New Albany Architectural Review Board Meeting Agenda
Monday, May 11, 2026, 7:00 p.m.

New Albany Architectural Review Board
Monday, April 13, 2026 Meeting Minutes - DRAFT

LOCATION: 7420 Walnut Street (PID: 222-004741)
REQUEST: Certificate of Appropriateness
ZONING: Agricultural District (AG) to Community Facilities (CF)
STRATEGIC PLAN: Residential
APPLICATION: ARB-06-2026
APPLICANT: City of New Albany c/o EMH&T

Proposed Temporary Parking

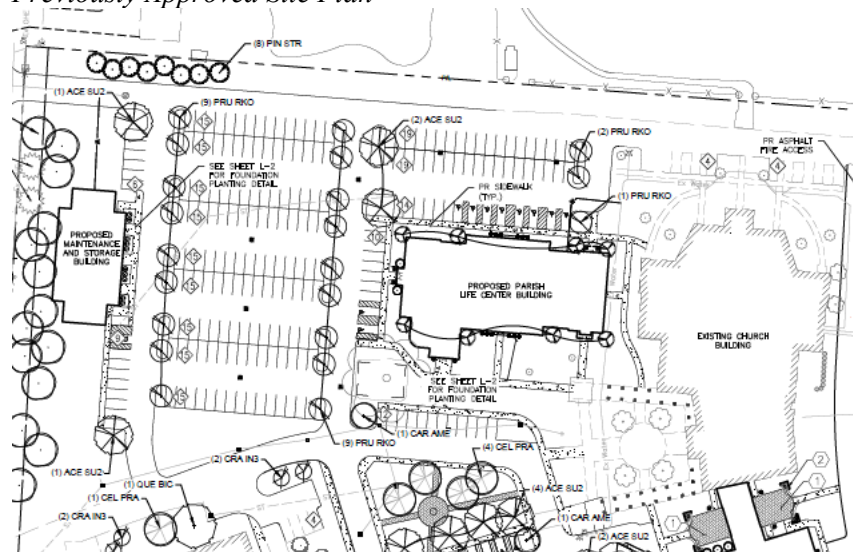
- The proposed temporary parking generally complies with the requirements set forth in the code however, it does not include a defined timeline for removal. Although plans for the Parish Life Building have been approved, construction is contingent upon securing additional funding, leaving the project schedule uncertain. As a result, the temporary nature of the parking lot cannot be clearly established at this time.

- No lighting changes or additions have been shown on the proposed plans.
- Staff recommends a condition of approval that if lighting is added, it must be cut-off fixtures and downcast designs, preventing spillage beyond the site's boundaries and matching the existing light features currently on the site, subject to staff approval (condition #1).

1. If lighting is added, it must be cut-off fixtures and downcast designs, preventing spillage beyond the site's boundaries and matching the existing light features currently on the site, subject to staff approval.
2. If signage is added, it meets all applicable codes and is subject to staff approval.

Image: Proposed monument sign.

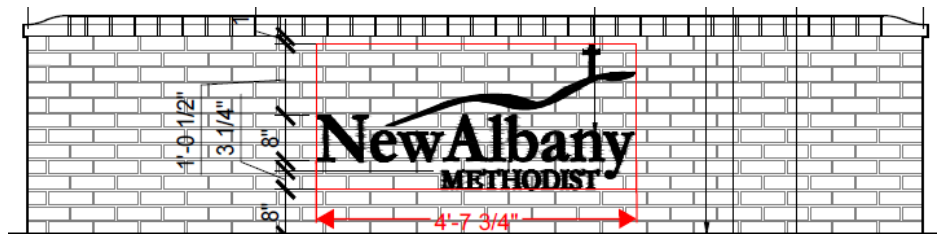
- C.O. 1169.17(c) does not permit monument signs in the Campus sub-district of the Village Center. The applicant is requesting a waiver to allow the monument sign. For other sub-districts and use categories, the city sign code has the following requirements:

Approved

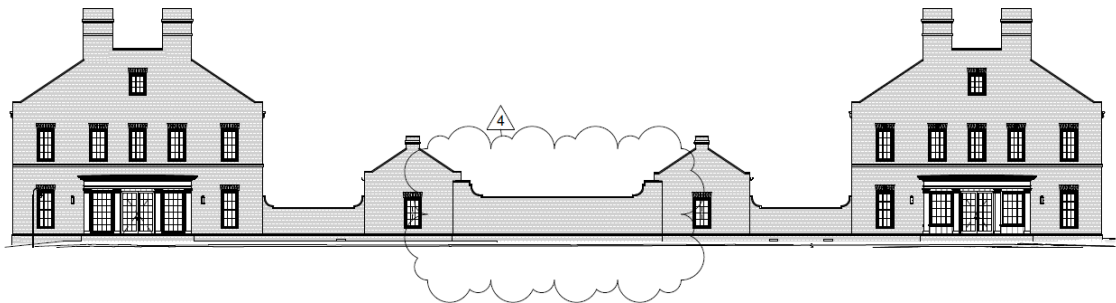
- The applicant proposes redesigning the brick wall along Main Street by eliminating the window well cutout, light fixtures along the brick wall, and altering the cap details.

- The brick wall is now proposed to feature a blank façade with a consistent height along Main Street between the two units. The previous design of the brick retaining wall was approved with a condition that states, “Guardrails at the window wells and iron work on the center Main Street retaining wall shall be subject to staff approval if required.” Since the new design proposal does not include these specific details as part of the condition of approval from ARB-106-2023, the application has come back to ARB for approval of the changes.
